PALISADES PLANT

Amendment No.27
License No. DPR-20

ATTACHMENT TO LICENSE AMENDMENT NO. 27
PROVISIONAL OPERATING LICENSE NO. DPR-20
DOCKET NO. 50-255

SAFETY EVALUATION BY THE OFFICE OF NUCLEAR REACTOR REGULATION
SUPPORTING AMENDMENT NO. 27 TO PROVISIONAL OPERATING LICENSE NO. DPR-20

Figure 3-1

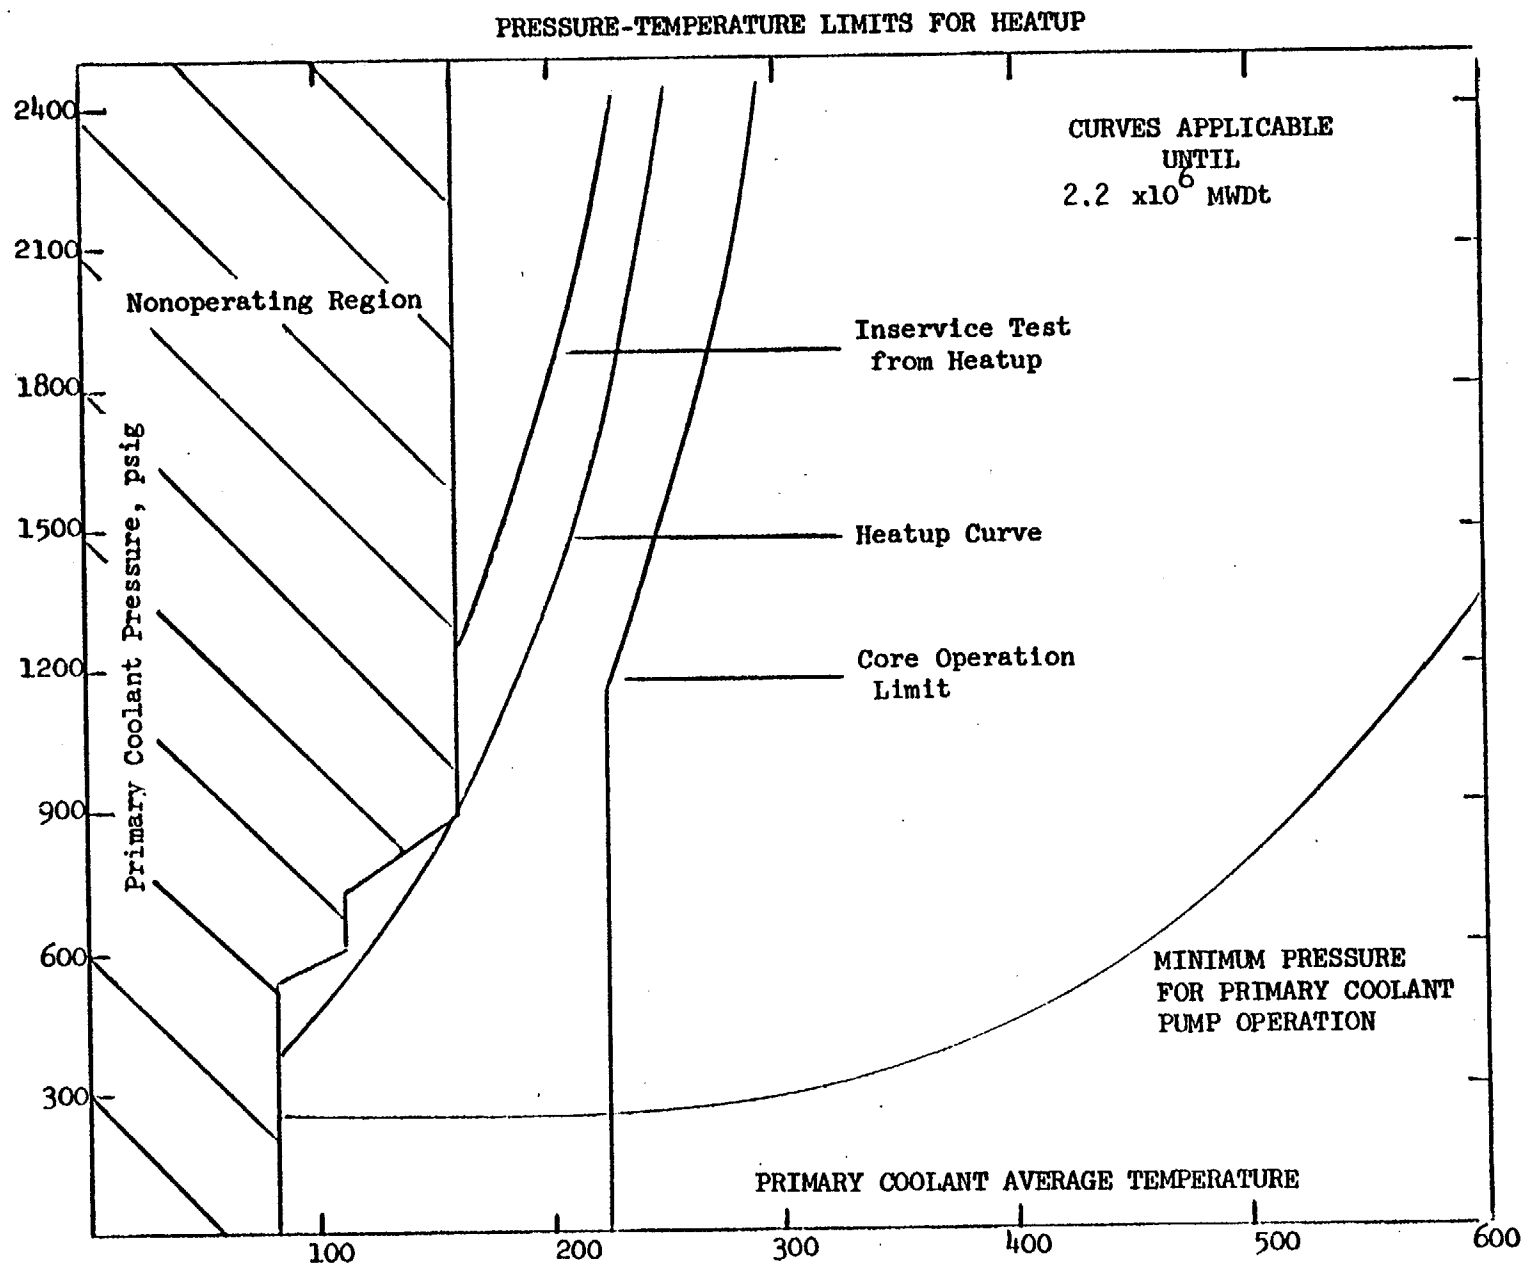
- a. Allowable combinations of pressure and temperature for any heatup rate shall be below and to the right of the limit lines as shown on Figure 3-1. The average heatup rate shall not exceed 60°F/h in any one-hour time period.

The limit lines of Figures 3-1 and 3-2 consider a 54 psi pressure allowance to account for the fact that pressure is measured in the pressurizer rather than at the vessel beltline. In addition, for calculational purposes, 5°F and 30 psi were taken as measurement error allowances for temperature and pressure respectively. These allowances deviate slightly from those of previous technical specifications yet the effect upon the heatup and cooldown curves is negligible. By Reference (6), reactor vessel wall locations at 1/4 and 3/4 thickness are limiting. It is at these locations that the crack propagation

The revised pressure-temperature limits are applicable to reactor vessel inner wall fluences up to 2.6×10^{18} nvt or approximately 2.2×10^6 MWD of thermal reactor power. The previous revision of the pressure-temperature limits is conservative with respect to the revised procedures of References (5, 6, 7) up to 1.8×10^{18} nvt or approximately 1.5×10^6 MWD thermal. The application of fluence attenuation factors at the 1/4 and 3/4 thickness location results in section fluences of 1.34×10^{18} nvt and 3.1×10^{17} nvt respectively. It may be determined from Figure 3-3 that the appropriate NDTT shifts are 85 °F at the 1/4 thickness location (heatup or cooldown limiting) and 40°F at the 3/4 thickness location (heatup

- (3) The limit lines in Figure 3-1 and Figure 3-2 shall be moved parallel to the temperature axis (horizontal) in the direction of increasing temperature a distance equivalent to the transition temperature increase during the period since the curves were last constructed. For both figures, the lower vertical, intermediate and upper limit lines shall remain at 80°F, 110°F, and 160°F respectively, as they are set by the NDTT of the reactor vessel flange, steam generator and pressurizer manway covers, respectively, and are not subject to fast neutron flux. These vertical lines bound a nonoperating region defined by other than reactor vessel considerations. This area is that of previous technical specifications and it will not change in the future.

Figure 3-2

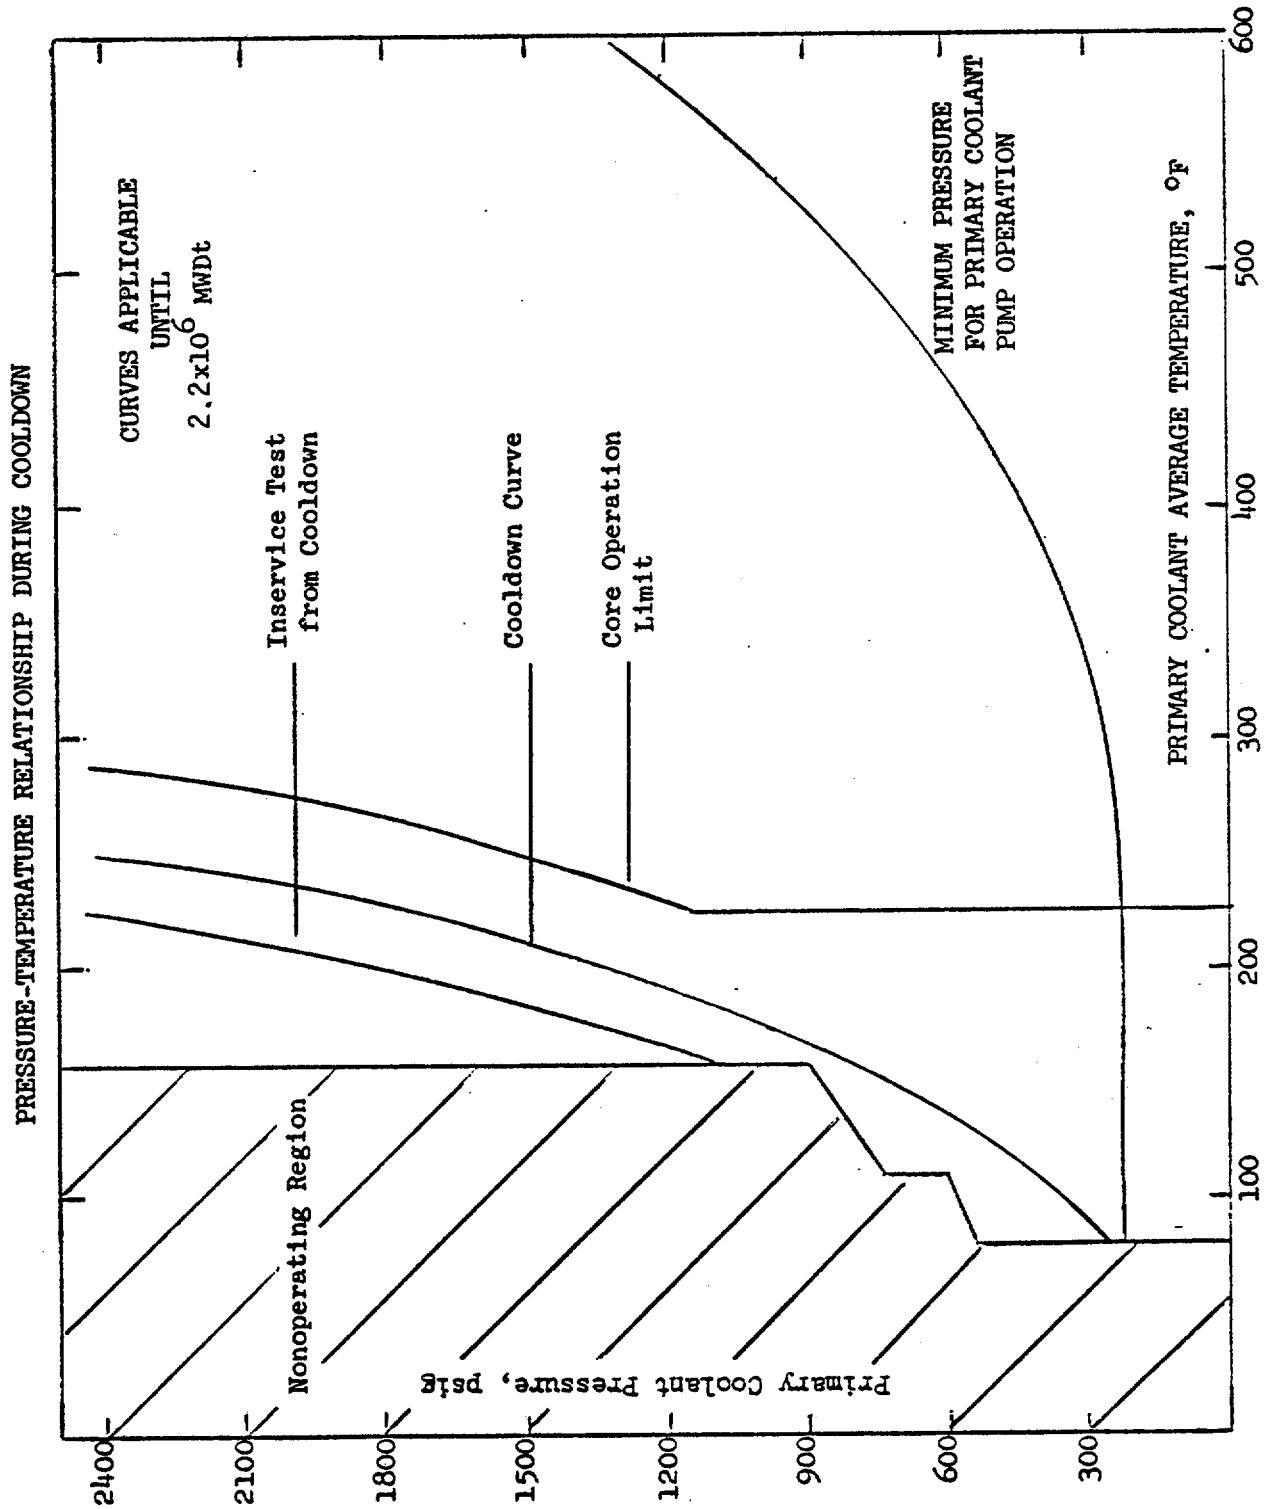
- b. Allowable combinations of pressure and temperature for any cooldown rate shall be below and to the right of the limit lines as shown on Figure 3-2. The average cooldown rate shall not exceed 100°F/h in any one-hour time period.

FIGURE 3-3

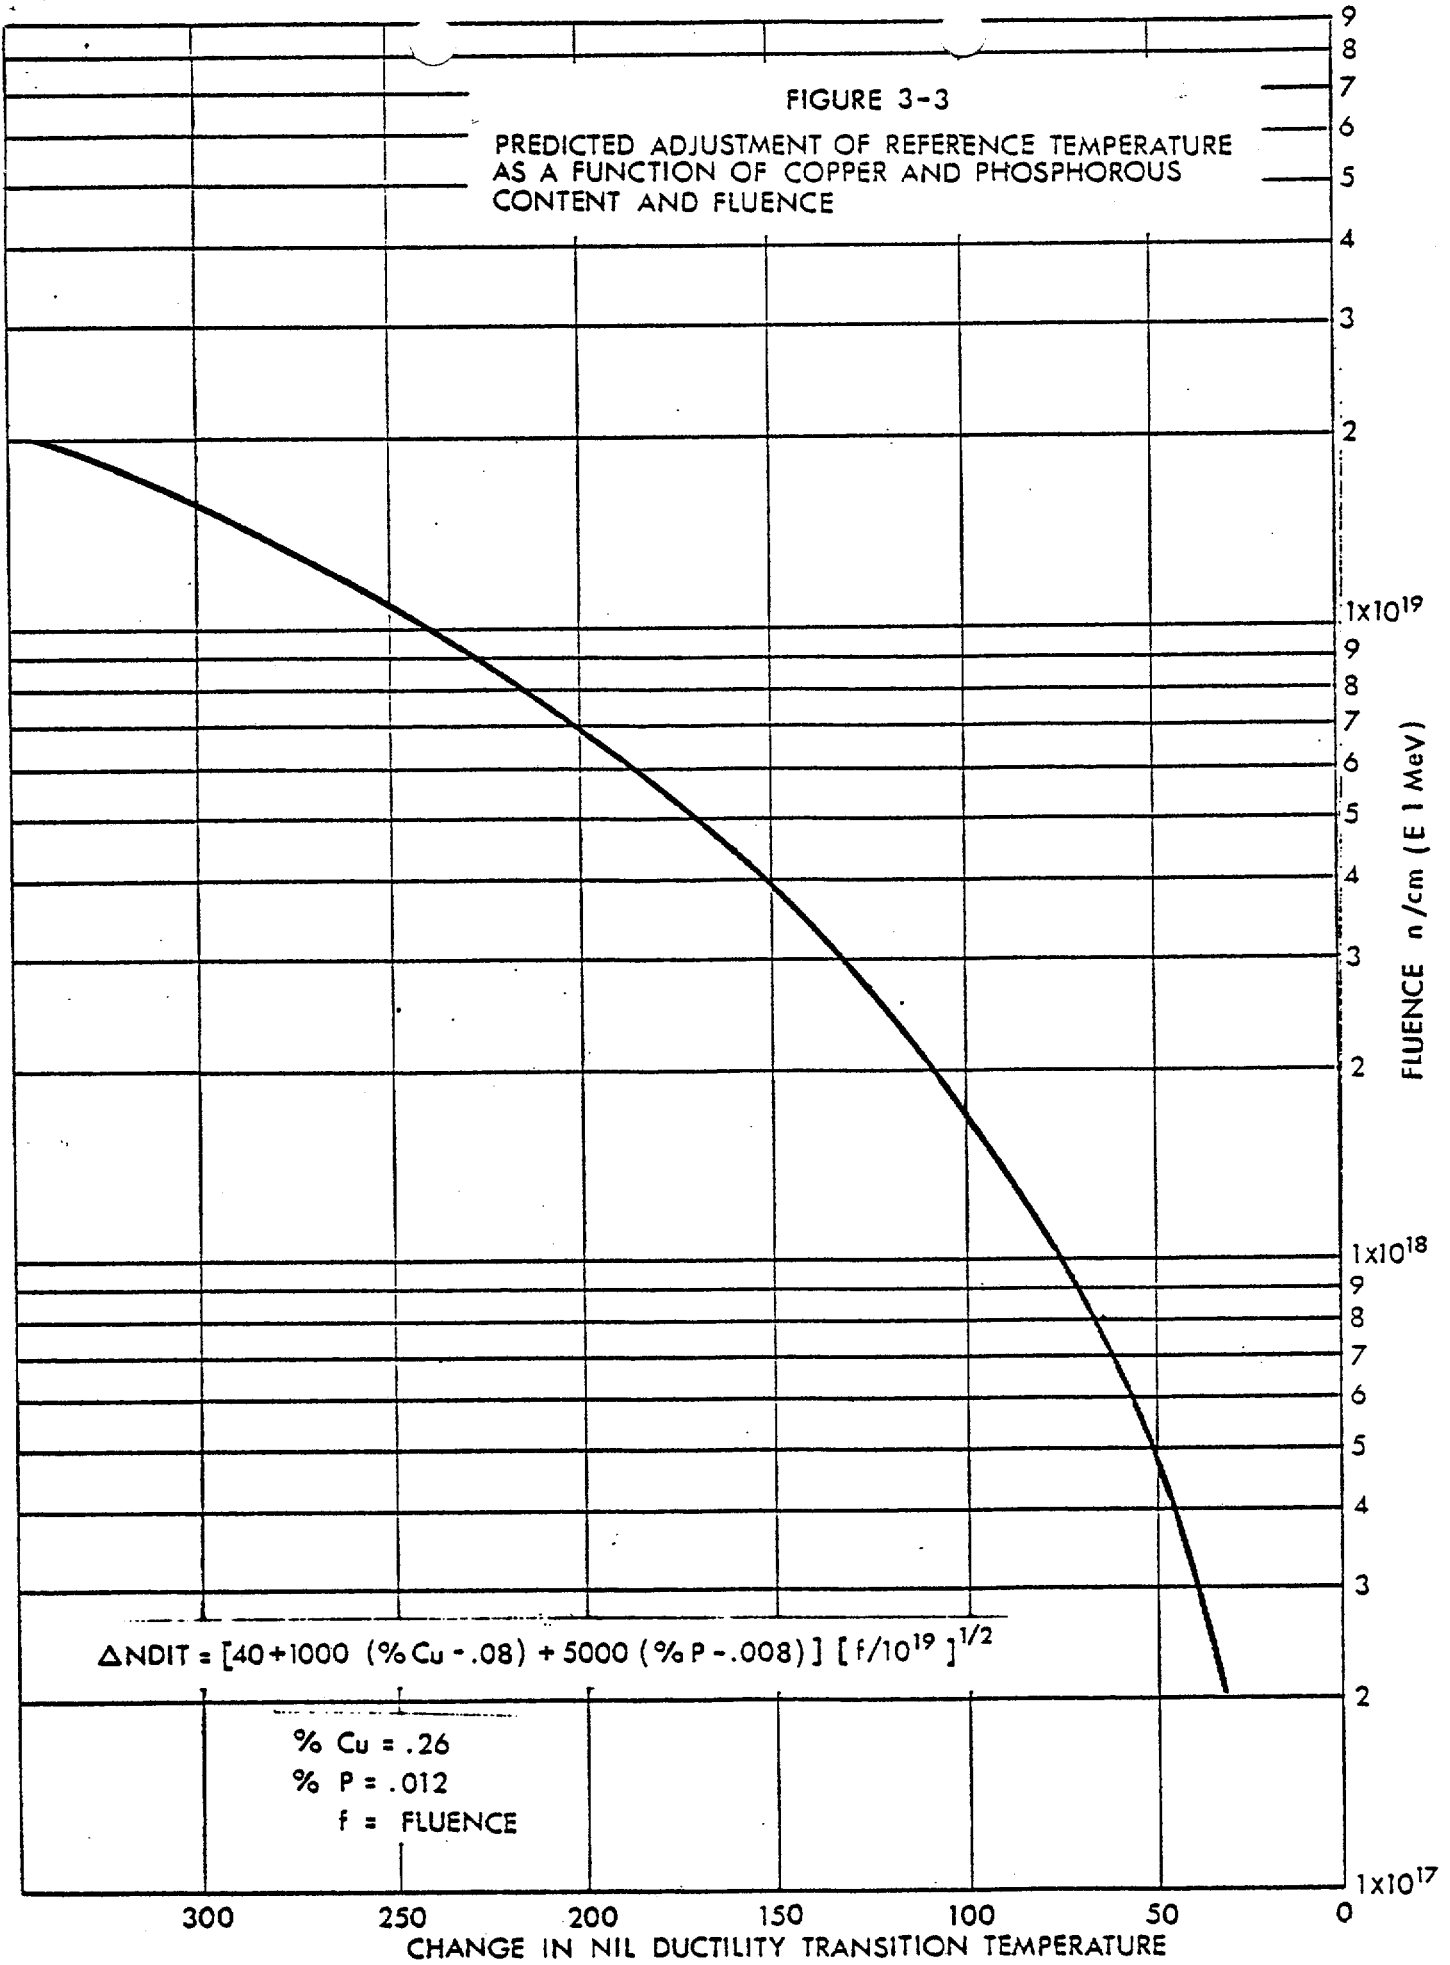
- (1) The curve in Figure 3-3 shall be used to predict the increase in transition temperature based on integrated fast neutron flux. If measurements on the irradiation specimens show increases above this curve, a new curve shall be constructed
